POLICY REPORT DEVELOPMENT AND BUILDING

TO: Vancouver City Council
FROM: General Manager of Planning and Development Services
SUBJECT: CD-1 Rezoning: 2610 Victoria Drive

Figure 6a: Site Plan

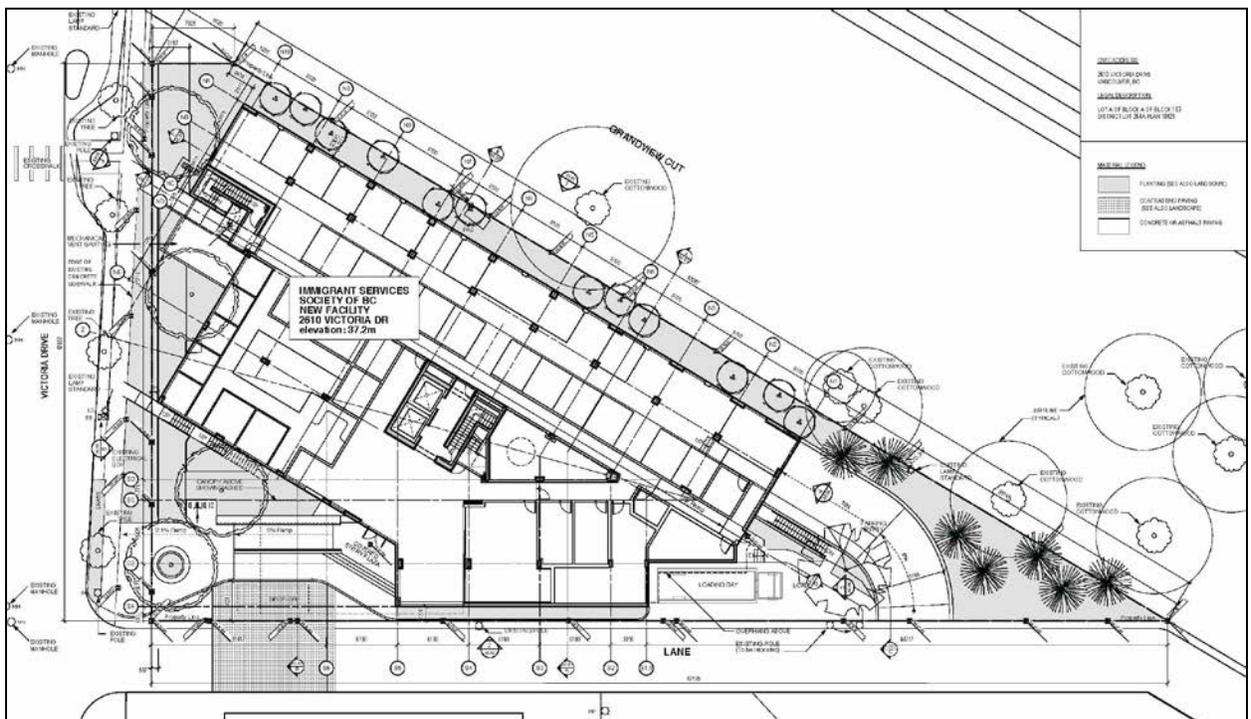
- 1. Design development to improve entrance wayfinding and a more interactive relationship with the public realm by relocating the main entry to a position that is closer to the public sidewalk and roadway on Victoria Drive.

Note to Applicant: The current proposal shows a main entrance that is deeply set back from the front property line. Moving this entrance closer to the Victoria Drive curb to a distance of no more than 15 m would successfully address this condition while simultaneously addressing conformance to the Vancouver Building By-Law (refer to comments from the Building Code Specialist, included in Appendix E).

6. Revision of the Landscape Plan to accommodate the required fire access path.

Note to Applicant: The maximum travel distance allowed for the fire access path is 15 m, as measured from the street curb to the main entry door. Refer to Condition 8 (Engineering) in Conditions of Approval to the Form of Development.

1. *Fire Department access does not conform to the requirements of Article 3.2.5.5 of the Building By-law, specifically Clause 3.2.5.5.(2).(b) which limits the distance from the access route (Victoria Drive) to the principle entrance to a maximum of 15 m. As shown on the submitted site plan the proposed distance exceeds the allowable 15 m. It is also noted that the site plan is drawn at 1:150 rather than the 1:300 scale which has been indicated in the title block of sheet A1.00.

Figure 8: Typical Floor Plan

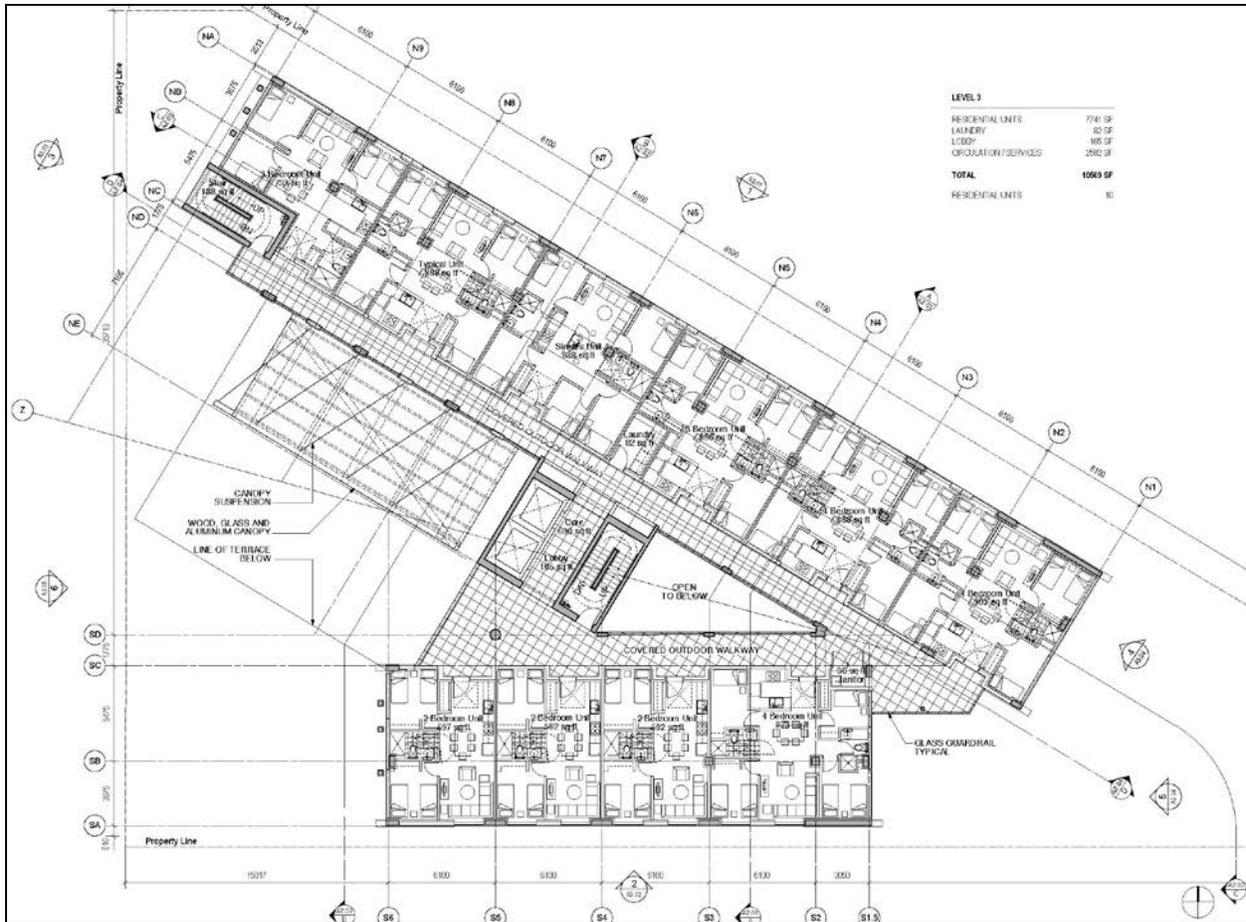
3. *To the East of the central exit stair at Levels 2 thru 5 of the building there are public corridors (exterior walkways) that exceed the maximum allowable length of 6 m and which only provide access to a single exit from those parts of the public corridor that exceed 6 m length. The design contravenes Clause 3.3.1.3.(8) and Sentences 3.3.1.3.(9) and 3.3.1.9.(7) of the Building By-law which requires that it be possible to go in opposite directions to each of 2 separate exits.

4. *The covered walkways at levels 2 thru 5 of the building do not conform to Article 3.4.4.3 ("Exterior Passageway Exceptions") of the Building By-law and will be reviewed as public corridors which are required to be separated from the remainder of the building by a fire separation as per Article 3.3.1.4 of the Building By-law.

5. The common laundry rooms at levels 3 thru 5 of the building must be accessible to disabled persons as per Clause 3.8.2.27.(4).(e) of the Building By-law. The doors shown do not have the clearances to the latched side nor the clear level areas as required by Sub-Clauses 3.3.1.13.(10).(b).(i) and (ii) of the Building By-law.

Figure 9: East Elevation

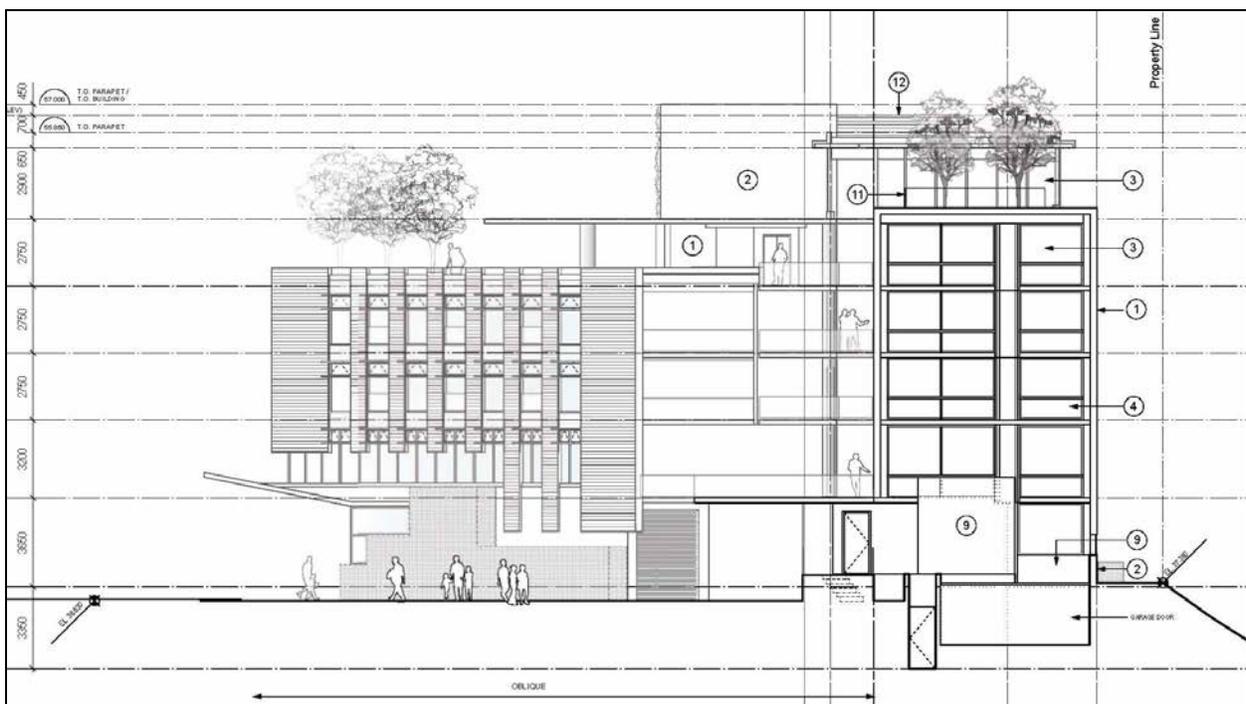
- 2. Consideration to provide further interest and variety to the northeast-facing elevation.

Note to Applicant: Facing the Grandview Cut, the Central Valley Greenway and the residential neighbourhood to the north, the northeast elevation is a prominent façade as viewed from significant portions of the public realm. The current proposal shows a highly repetitive pattern of window bays that spans approximately 180 ft. in length, which is considered out-of-character with the surrounding residential context. An effort to visually break down this elevation would help diminish the overall scale, height and size, as well as reducing the institutional character that the proposal currently conveys.

The Panel thought there wasn't any problem with the overlook on the northeast elevation as it is filtered through trees. The calmness of the northeast elevation reinforces the strength of the composition of the building. One Panel member thought the north side of the building had a more institutional expression and suggested the application could soften the expression with landscaping.
